SUBJECT: LASALLE COUNTY STATION, UNITS 1 AND 2, ISSUANCE OF AMENDMENT  
REVISING THE ULTIMATE HEAT SINK TEMPERATURE LIMIT (CAC NOS.  
ME9076 AND ME9077)

The U.S. Nuclear Regulatory Commission (NRC or the Commission) has issued the enclosed Amendment Nos. 218 and 204 to Facility Operating License Nos. NPF-11 and NPF-18 for the LaSalle County Station (LSCS), Units 1 and 2, respectively. The amendments are in response to your application dated July 12, 2012, as supplemented by letters dated September 17, 2012, January 18, 2013, February 11, 2013, October 4, 2013, December 4, 2014, and April 15, 2015.

The amendments add a condition to Technical Specification 3.7.3, requiring performance of Surveillance Requirement (SR) 3.7.3.1 once per hour if Core Standby Cooling System Pond temperature is  $\geq 101^{\circ}\text{F}$ , and also modifies the temperature limit specified in SR 3.7.3.1 from " $\leq 101.25^{\circ}\text{F}$ " to "within the limits of Figure 3.7.3-1." Figure 3.7.3-1, newly added by these amendments, provides diurnal temperature limits based on the time of day but that are no higher than  $104^{\circ}\text{F}$ .

SAFETY EVALUATION BY THE OFFICE OF NUCLEAR REACTOR REGULATION

Figure 3.7.3-1 (page 1 of 1)  
Temperature of Cooling Water Supplied to the Plant from the  
CSCS Pond Versus Time of Day Requirements

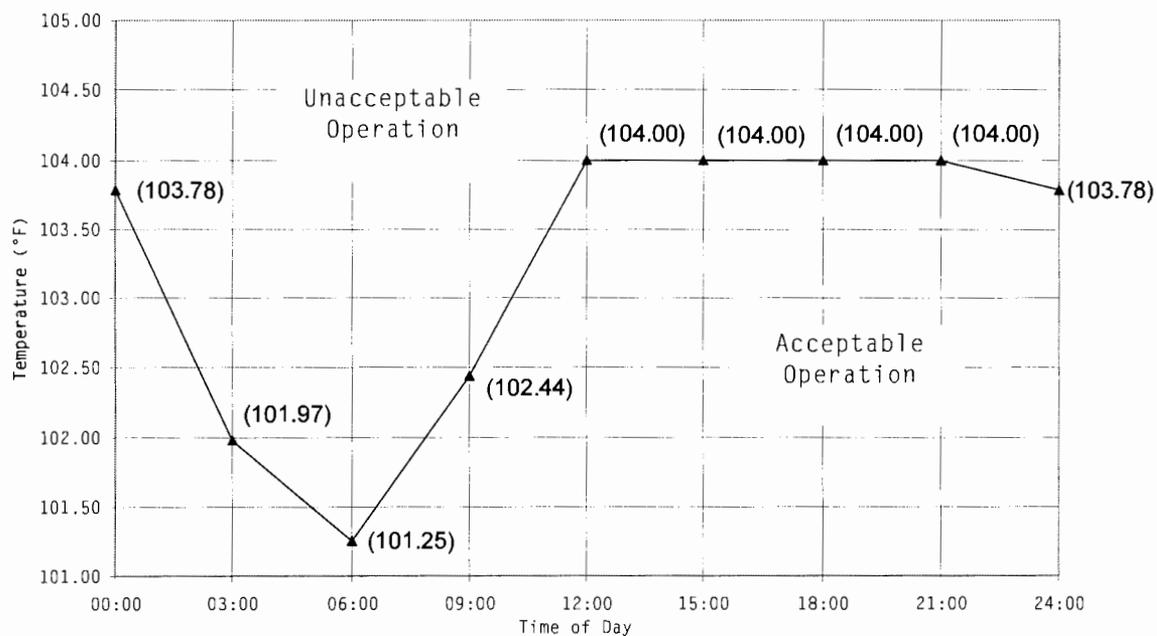
The license also proposed to add a CONDITION to TS 3.7.3, requiring performance of SR 3.7.3.1 once per hour if the core standby cooling system (CSCS) pond temperature is  $\geq 101$  °F. The licensee further proposed to modify the temperature limit specified in SR 3.7.3.1 from the current " $\leq 101.25$  °F" to "within the limits of Figure 3.7.3-1." The proposed Figure 3.7.3-1 provides diurnal temperature limits based on time of day.

Figure 3.7.3-1 (page 1 of 1)  
Temperature of Cooling Water Supplied to the Plant from the CSCS Pond Versus Time of Day Requirements

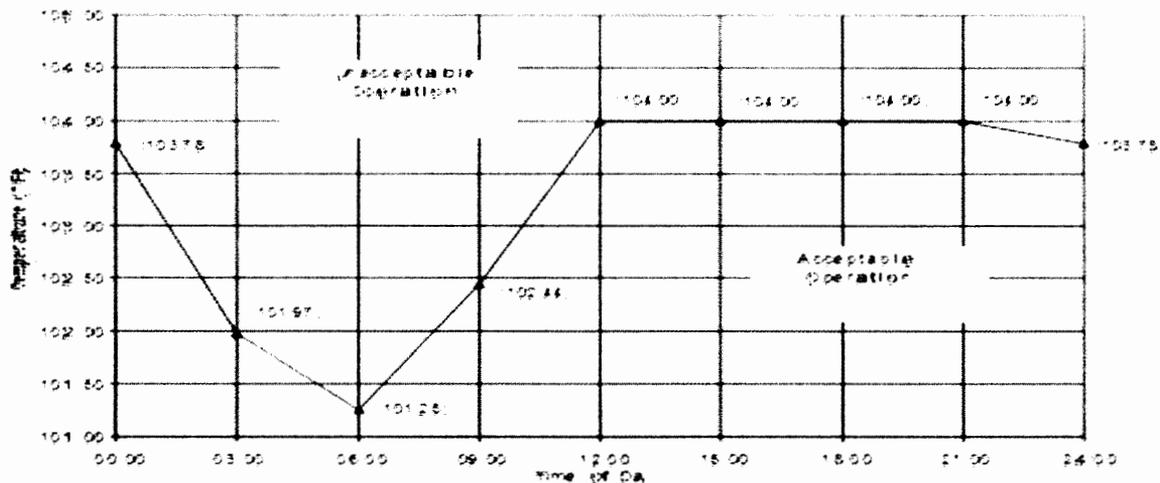
In this amendment request, the licensee proposes to revise the TS to allow the maximum UHS supply temperature, when in Modes 1-3, to be dependent on the time of day (diurnally dependent) such that the peak post-accident water supply temperature, based on analysis of the worst combination of pre-accident and post-accident conditions, will not exceed 107 °F. Specifically, the licensee proposes a revision to TS 3.7.3 by adding new Condition B, which would state "CONDITION: Cooling water temperature supplied to the plant from the CSCS pond  $\geq 101$  °F, REQUIRED ACTION: Perform SR 3.7.3.1., COMPLETION TIME: Once per hour."

SURVEILLANCE REQUIREMENT 3.7.3.1 currently reads, "Verify cooling water temperature supplied to the plant from the CSCS pond is  $\leq 101.25$  °F." The licensee proposes changing SR 3.7.3.1 to read, "Verify cooling water temperature supplied to the plant from the CSCS pond is within the limits of Figure 3.7.3-1." Proposed Figure 3.7.3-1 is provided below.
